CONTRACTOR DOCUMENT REVIEW

Aluminum Architectural Products
ACIP 005 100 073
By

225219.001

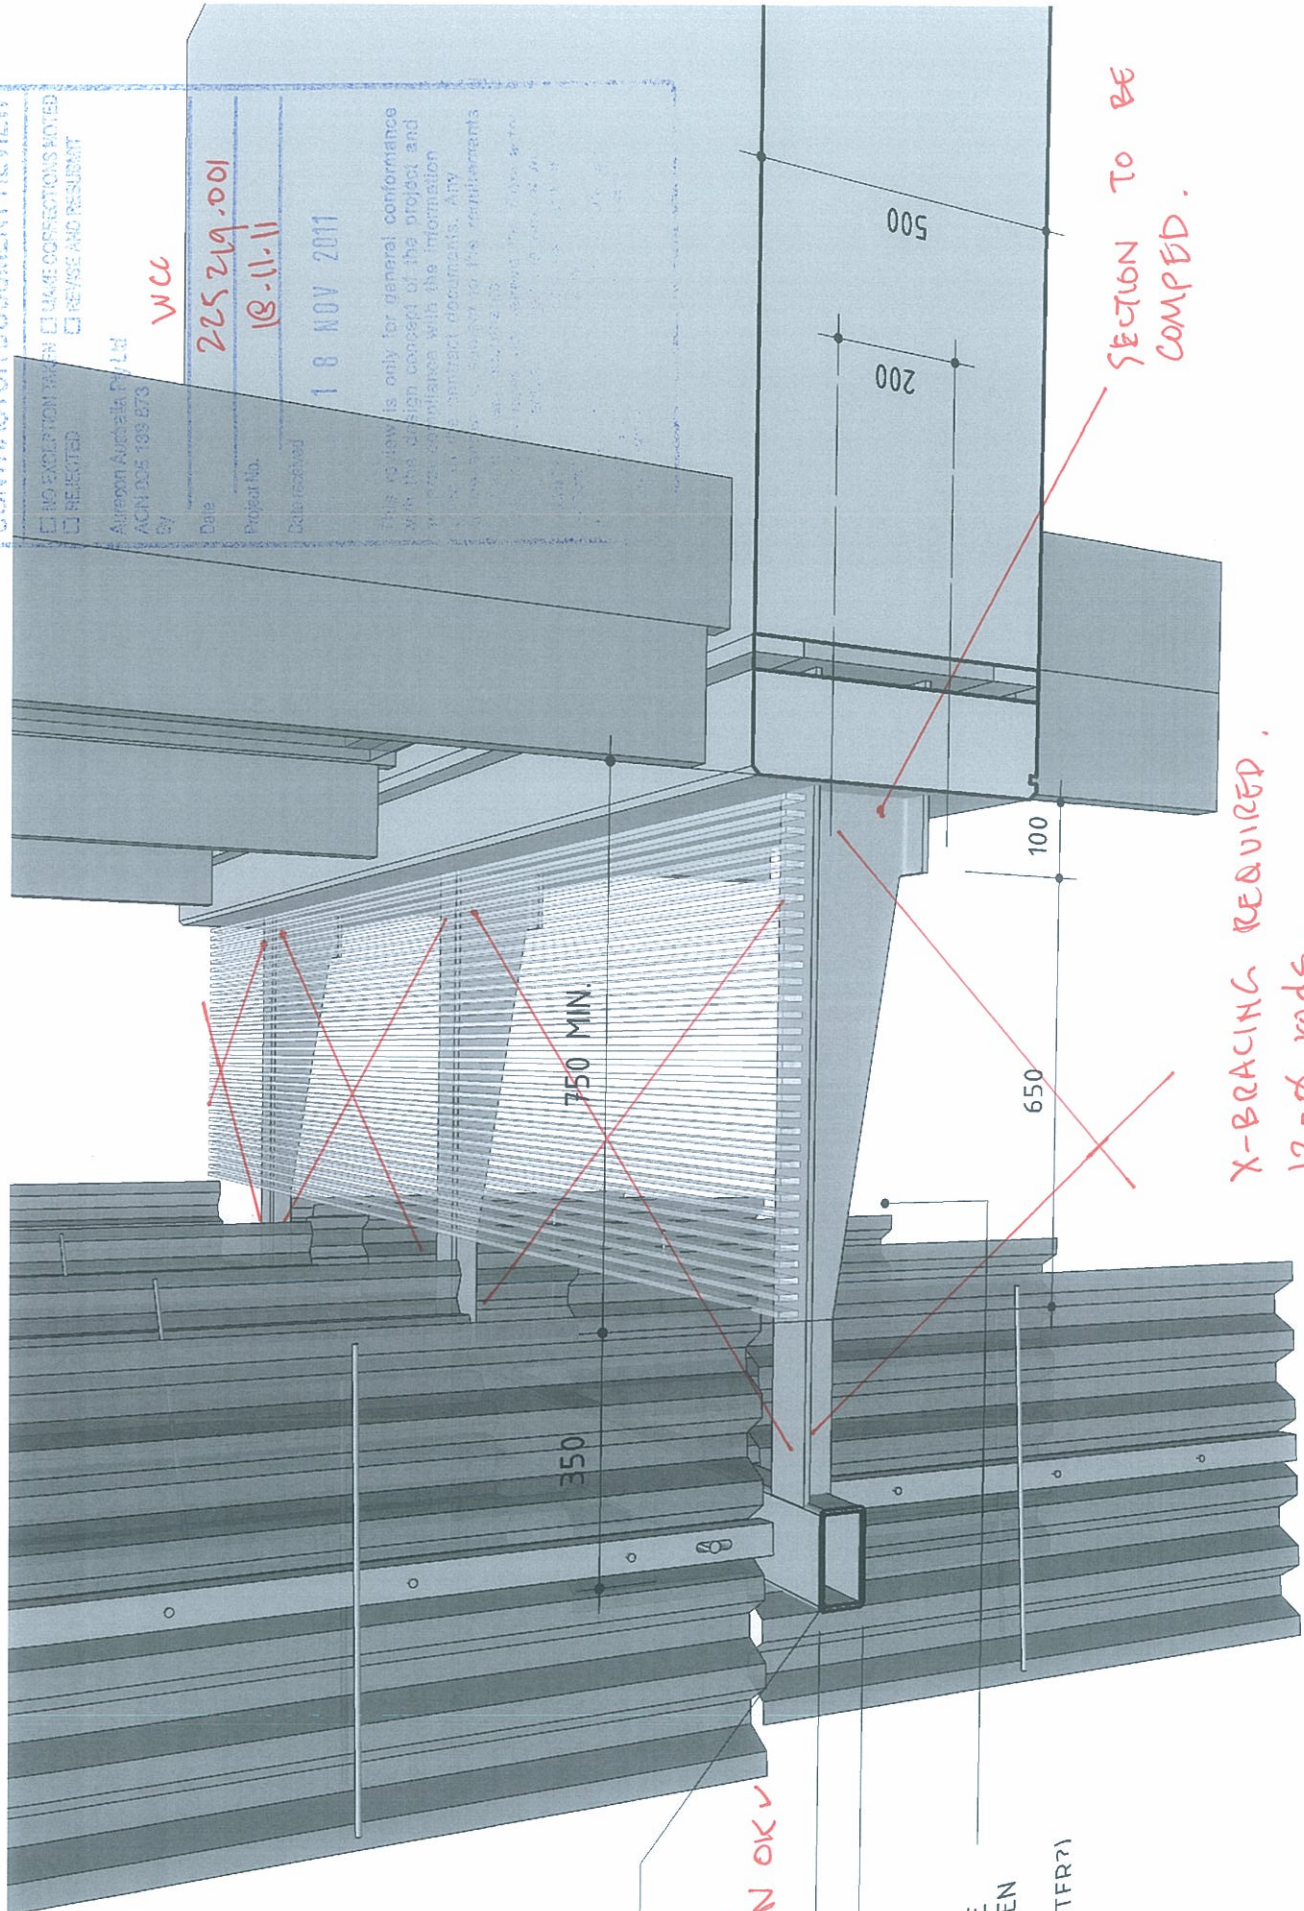
HSS TUBE
75(?) X 150(?)
125 X 75 RHS
for 1500 SPAN OK ✓

TAPERED W SHAPE
CATWALK & SCREEN
SUPPORT
(SPACING ON CENTER?)

X-BRACING REQUIRED,
12-φ rods.

SECTION TO BE
COMPED.
